**Town of Kittery
Planning Board Meeting
February 13, 2020**

ITEM 1 – 76 Dennett Road – Sidewalk/Street/Landscape Design Discussion

Re: Landscape Design Review
Response to Ironwood Design Group Review Comments
Proposed Mixed-Use Development at 76 Dennett Road
Tax Maps Lots 6-15B, 6-16A, 13-4, Kittery, Maine

**RE: Town of Kittery, Planning Board Services
Mixed-Use Development Proposal – 76 Dennett Road Lots 6-15B, 6-16A, 13-4
Final Review Comments - January 23, 2020 Submittal
CMA #591.125**

4 TYPICAL TREE PLANTING DETAILS
SCALE: NONE

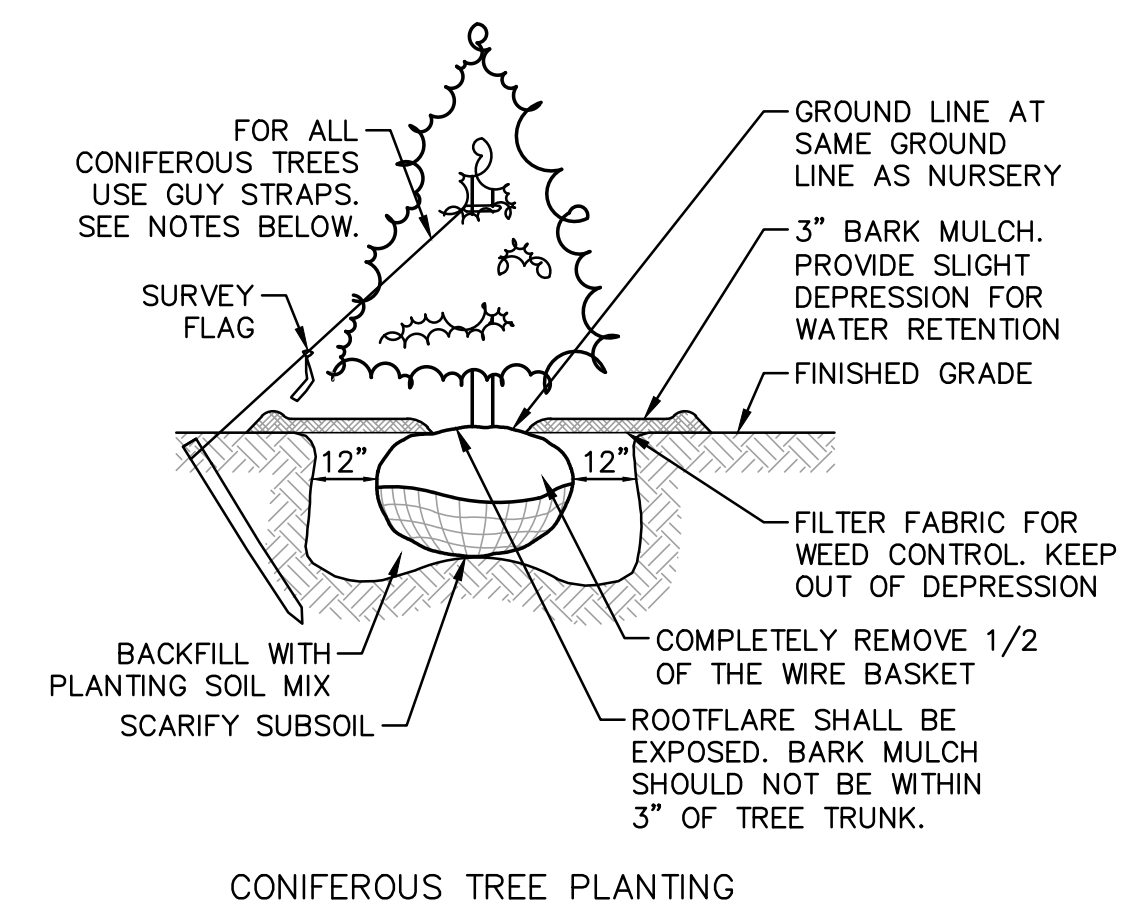
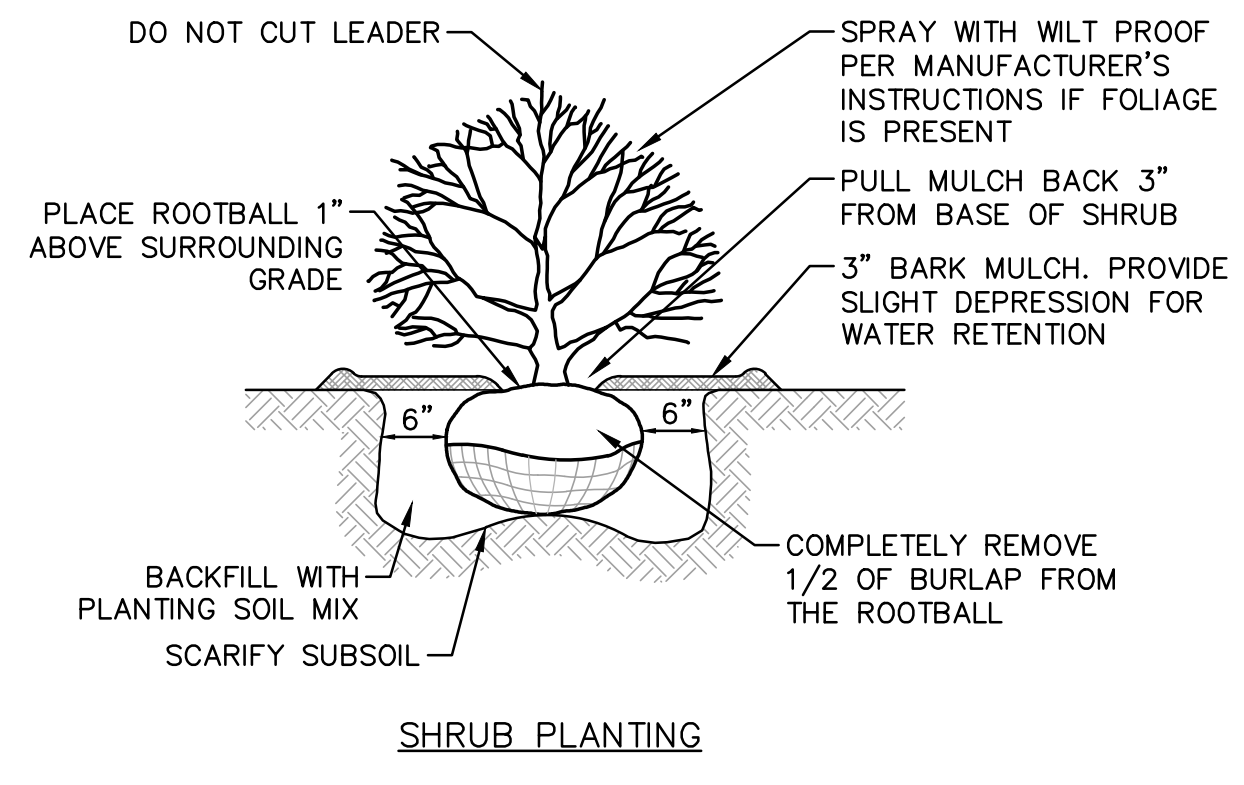
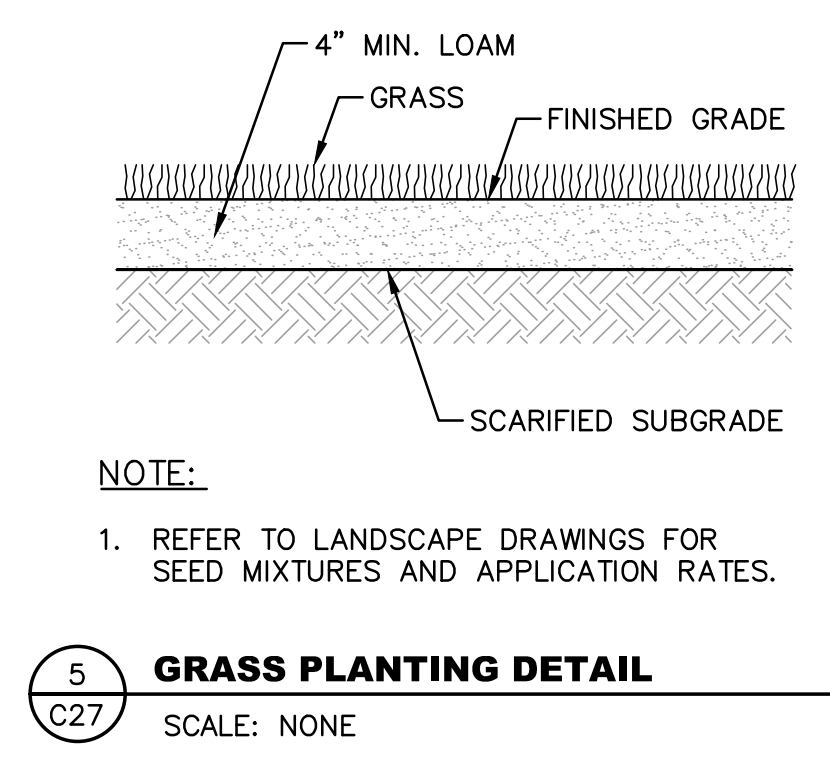
17. The following comments refer to Detail 10/C25 Typical Tree Planting:

- a. Replace galvanized wire with wide woven polypropylene straps to prevent gouging into tree trunk. Rubber hose does not provide adequate trunk protection.*
- b. Include a note that staking should be removed after two growing seasons.*
- c. Guying is recommended for deciduous trees greater than 6" caliper and all evergreen trees. Vertical stakes should be used for deciduous trees less than 6" caliper.*
- d. Details show mulch placed much higher than the plant's root flare. Included a note that root flare should be exposed above finished grade and mulch should be kept 3" away from base of tree.*
- e. To reduce the likelihood of settlement it is preferable to not over excavate the planting pit by 6".*
- f. Include a note that at least 1/2 of the wire basket should be removed completely.*

The typical tree planting detail was revised to include all the above comments. The detail has been relocated to #4 on sheet C27 due to additional details added to the plan set.
